PCN (Product Change Notice)

PCN Number: PCN_UtRJ45LAN_20250930

Affected Series: WE-RJ45LAN

7498210002

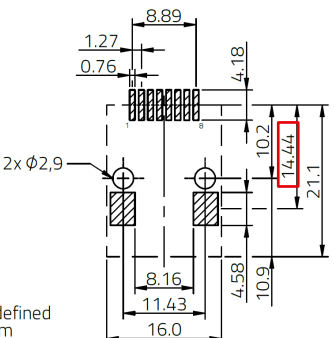
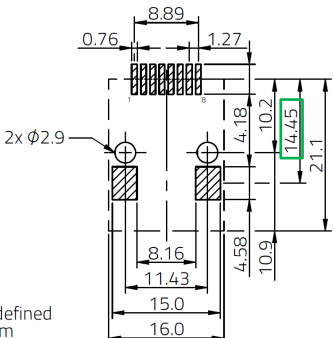
Before change	After change
 Unless otherwise defined tolerance: ±0.10mm Scale - 1.25:1	 Unless otherwise defined tolerance: ±0.10mm Scale - 1.25:1

74980110011

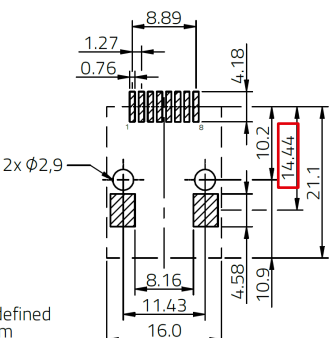
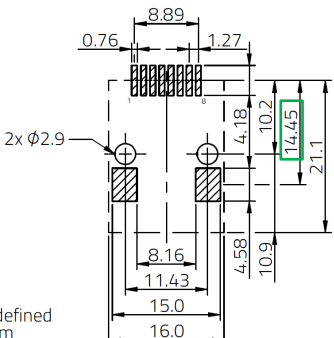
Before change	After change
 Unless otherwise defined tolerance: ±0.10mm Scale - 1.25:1	 Unless otherwise defined tolerance: ±0.10mm Scale - 1.25:1

7498011001A

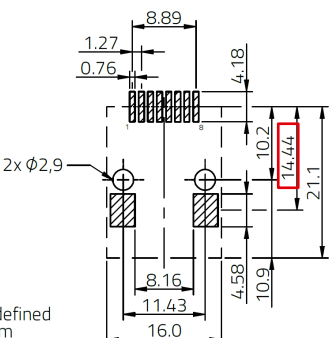
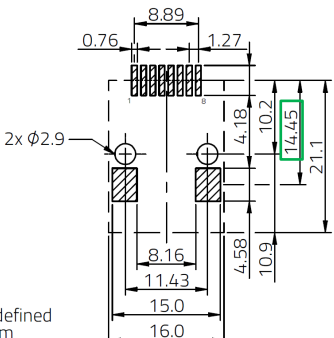
Before change	After change
 Unless otherwise defined tolerance: $\pm 0.10\text{mm}$ Scale - 1,25:1	 Unless otherwise defined tolerance: $\pm 0.10\text{mm}$ Scale - 1,25:1
